**MAINE DEPARTMENT OF
INLAND FISHERIES AND WILDLIFE**

ADDENDUM NO. 5

**IMPROVEMENTS AT GRAND LAKE STREAM STATE FISH HATCHERY
GRAND LAKE STREAM, MAINE**

BGS PROJECT NO.: 3289-14

15. SHEET 04D-404: SLUDGE STORAGE PROCESS PIPING PLAN & DETAILS, SECTION 2

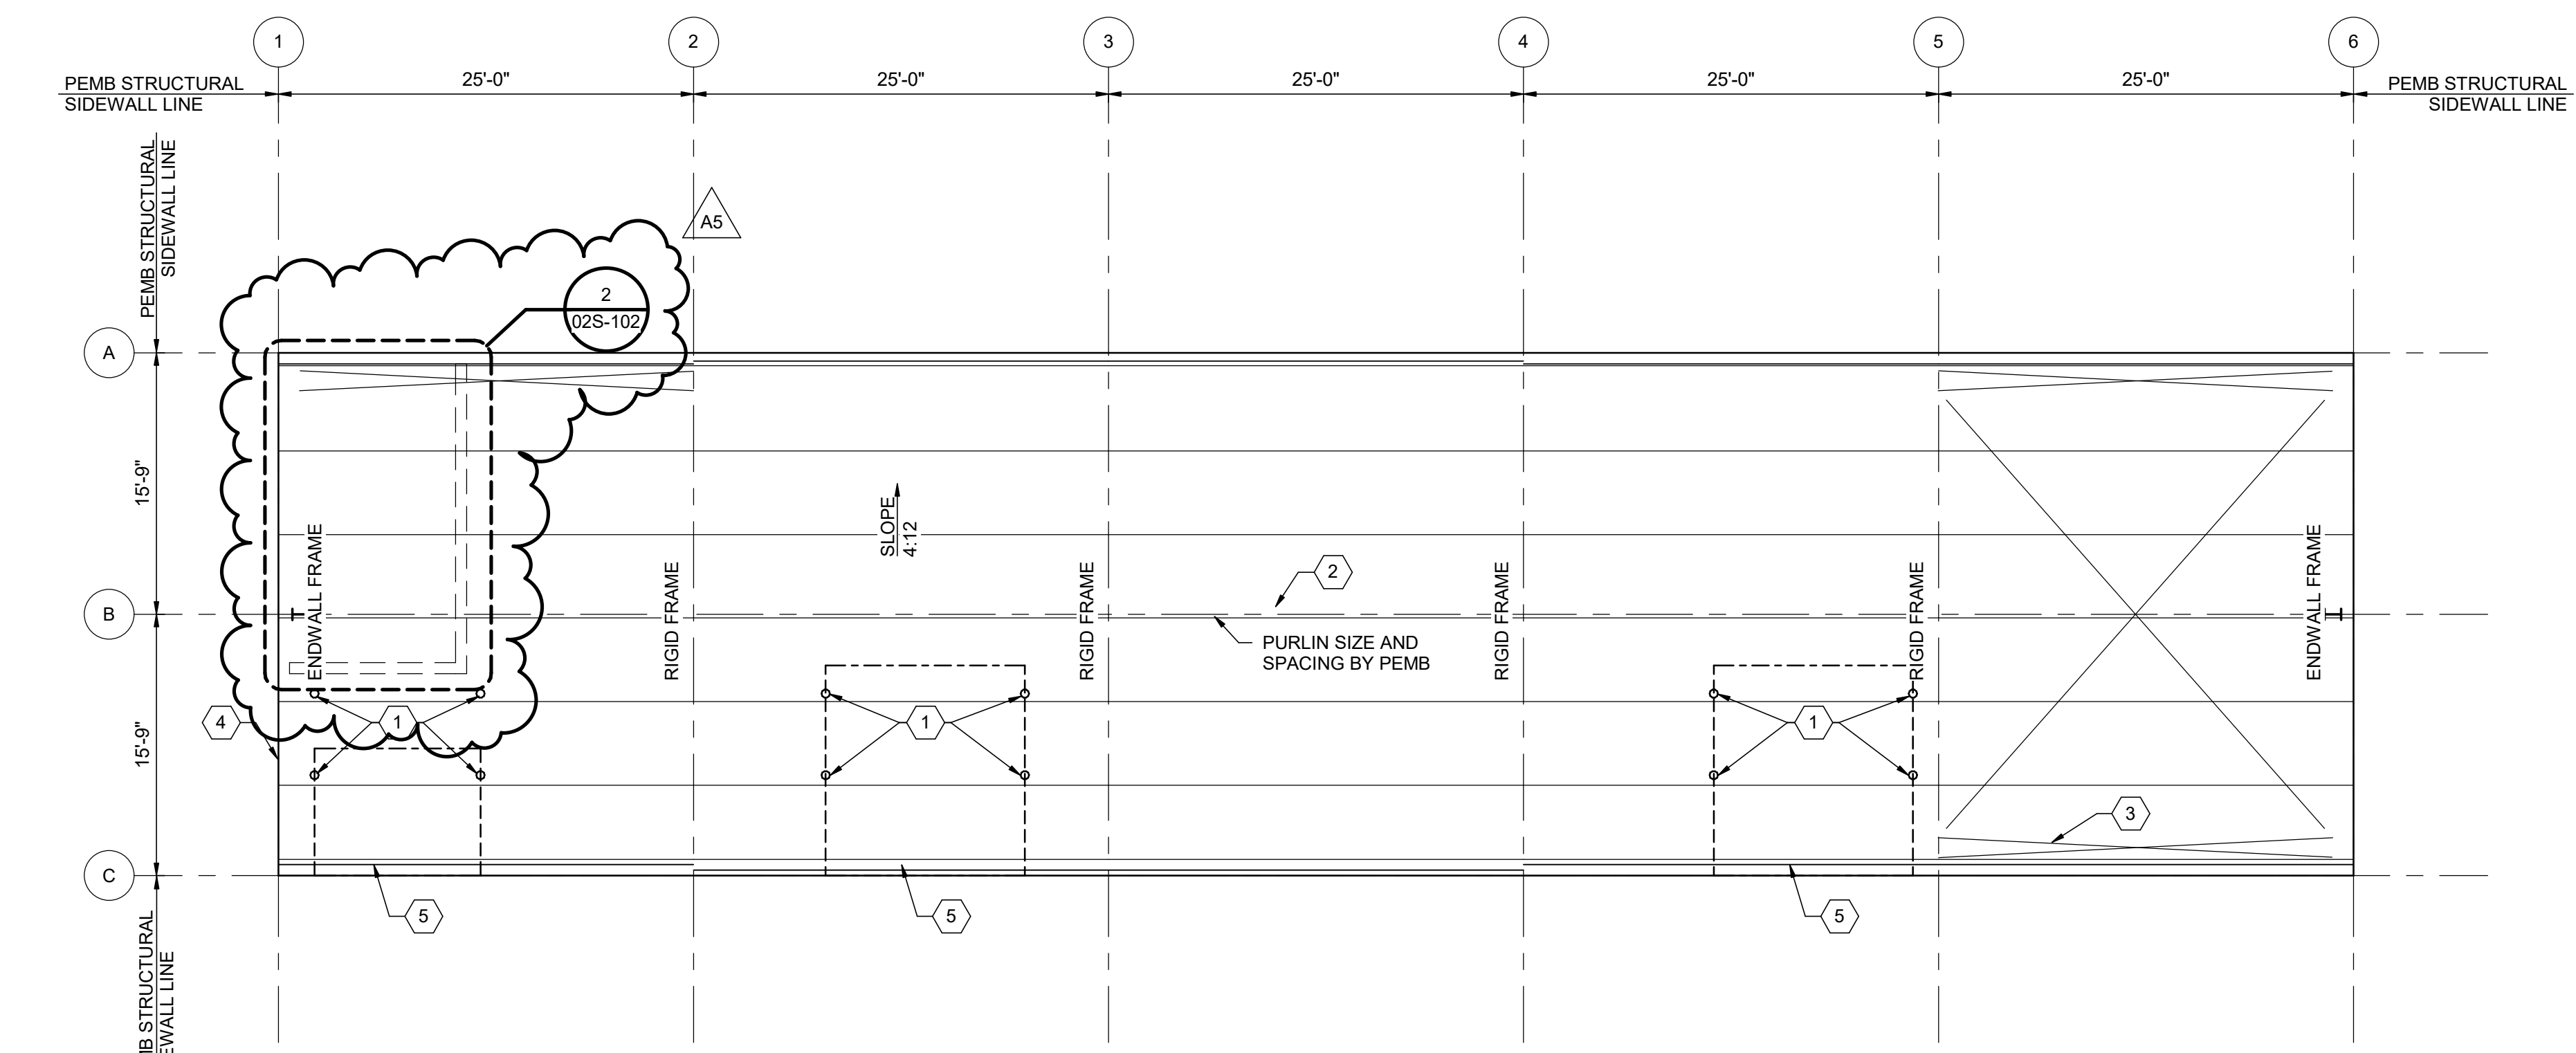
REPLACE: "24-IN ID MINIMUM HINGED & LOCK HASPED HATCH FOR CLEAR ACCESS INTO TANK" WITH "30-IN X 30-IN MINIMUM HINGED & LOCK HASPED HATCH FOR CLEAR ACCESS INTO TANK" See attached drawing.

SHEET
02S-102

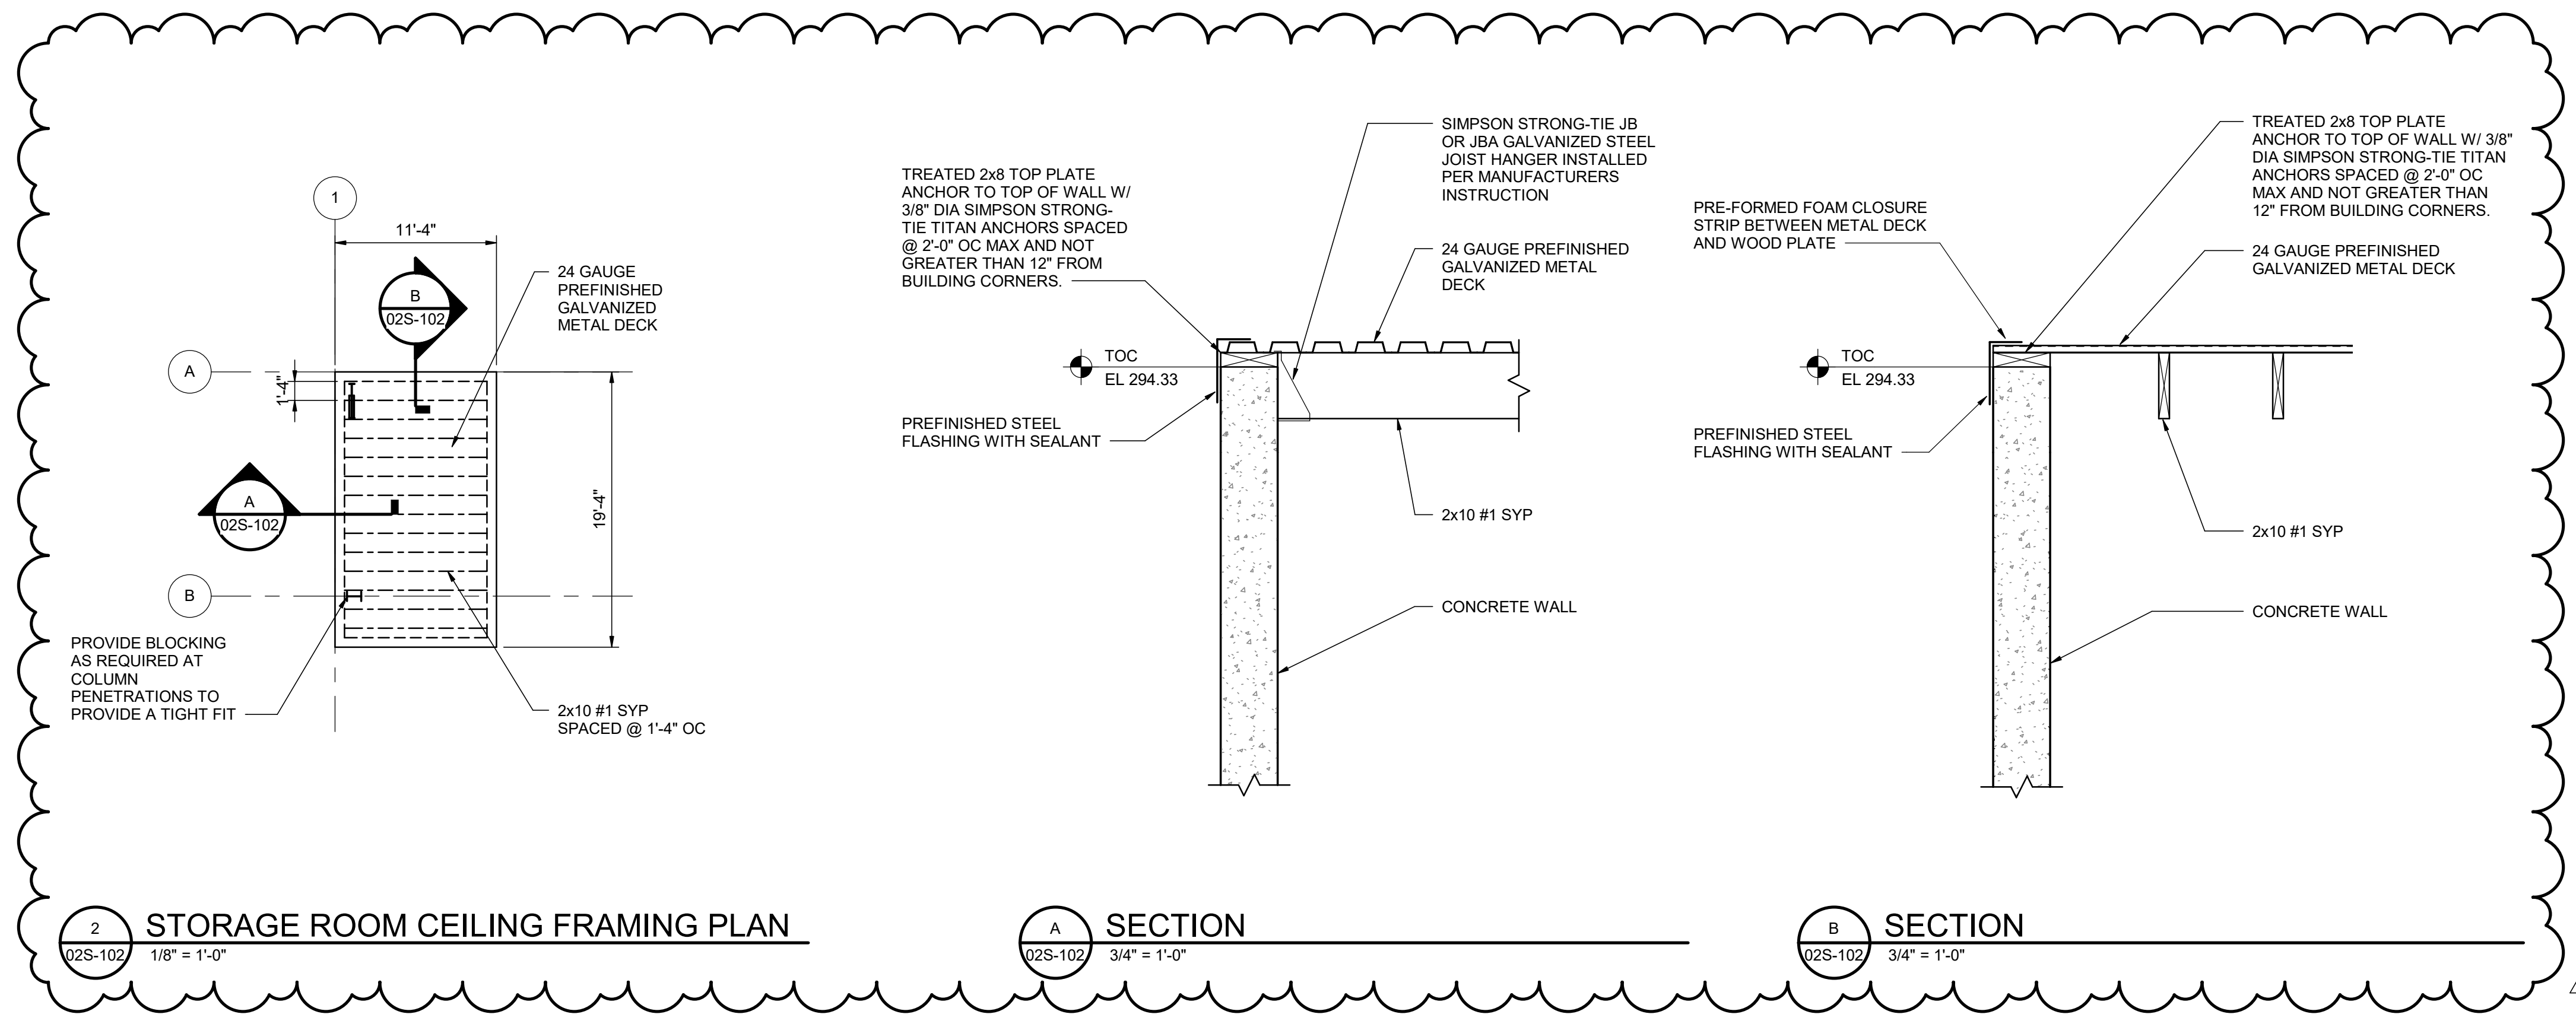
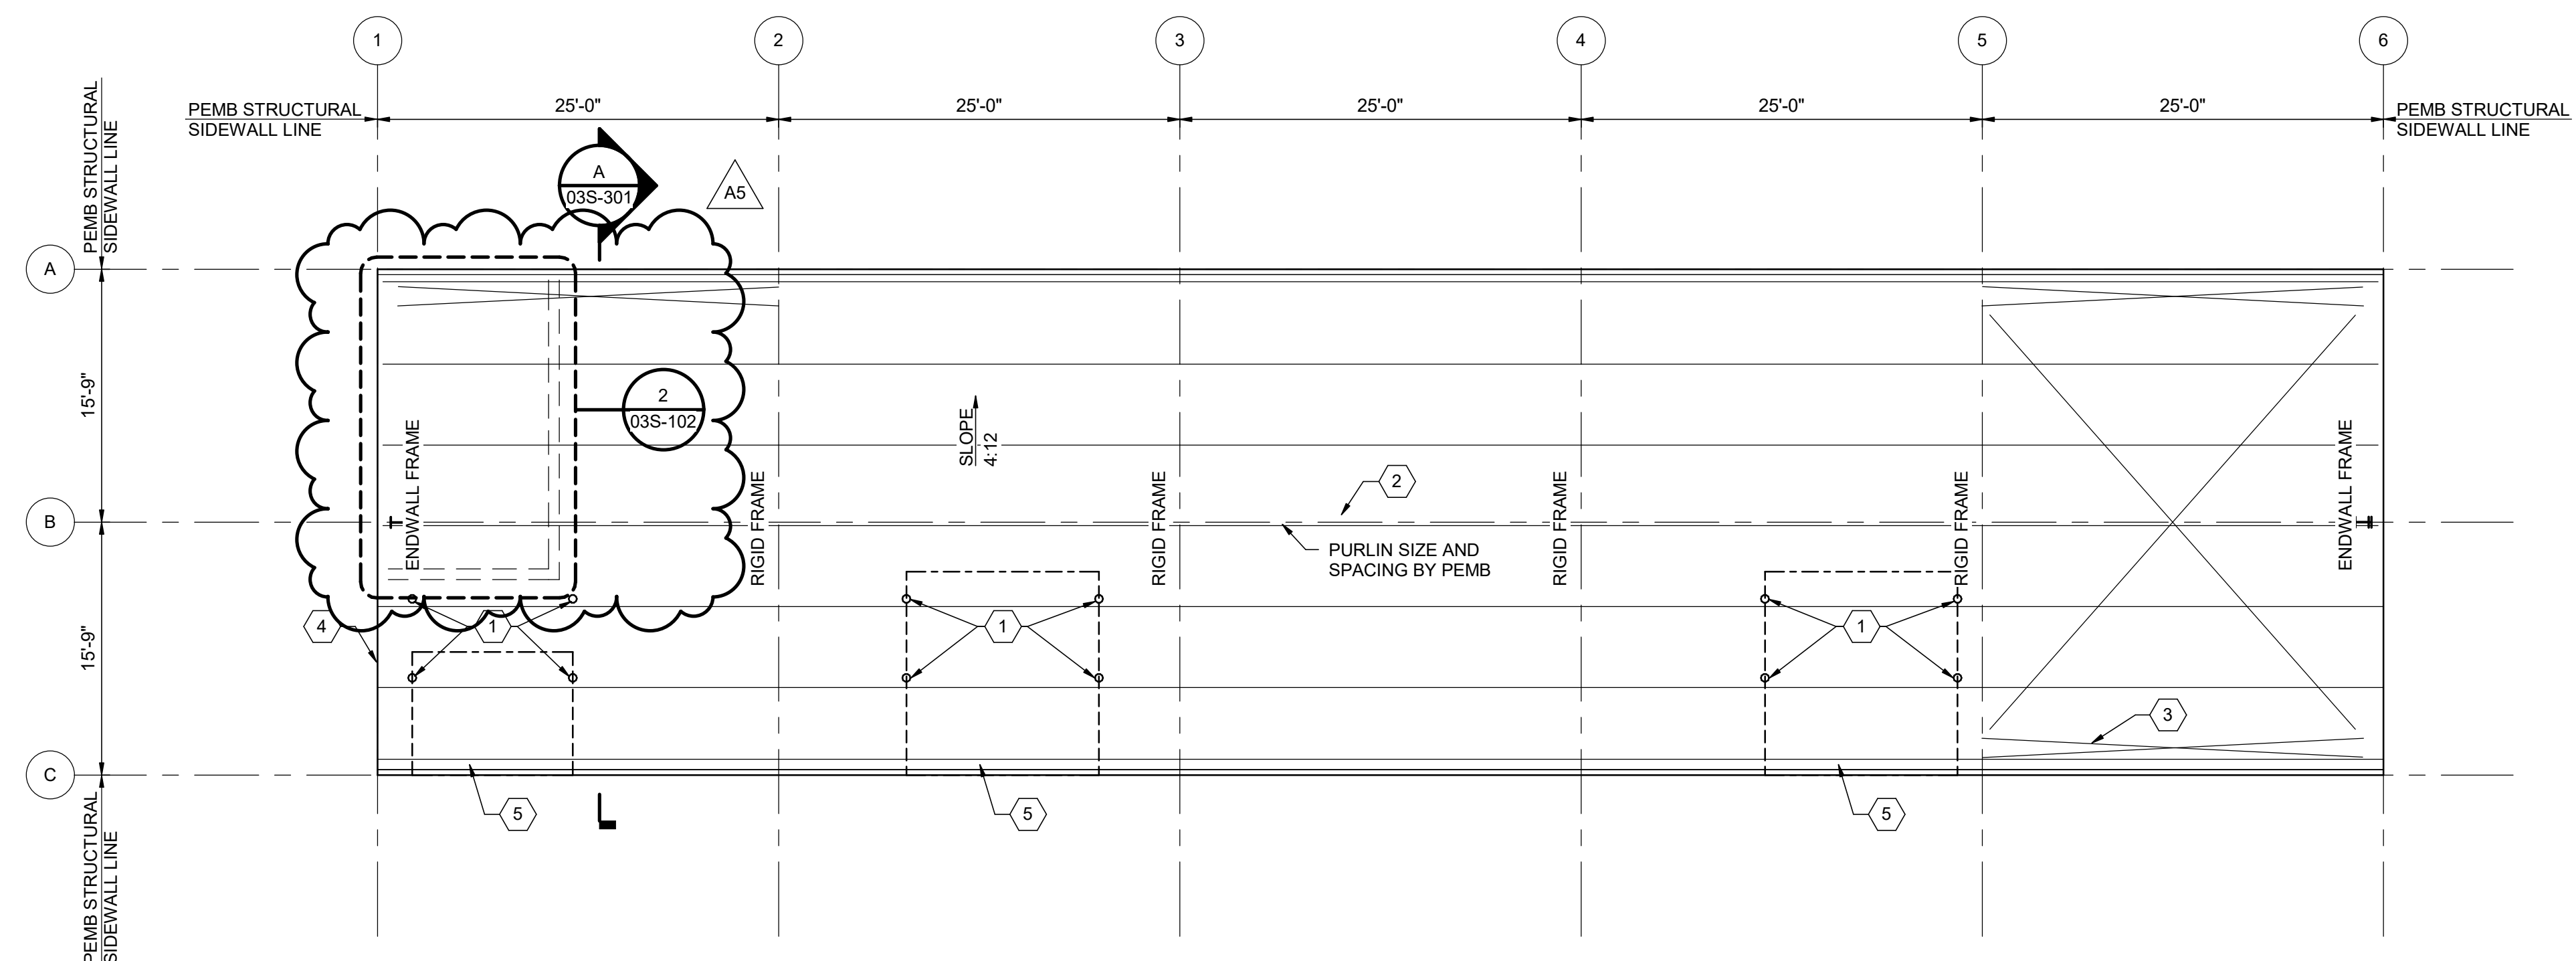
- 10. SHEET 02S-102: UPPER PAVILION FRAMING PLAN**
UPDATE: Sheet was updated to add additional details for storage room ceiling. See attached drawing.
- 11. SHEET 03S-102: LOWER PAVILION FRAMING PLAN**
UPDATE: Sheet was updated to add additional details for storage room ceiling. See attached drawing.
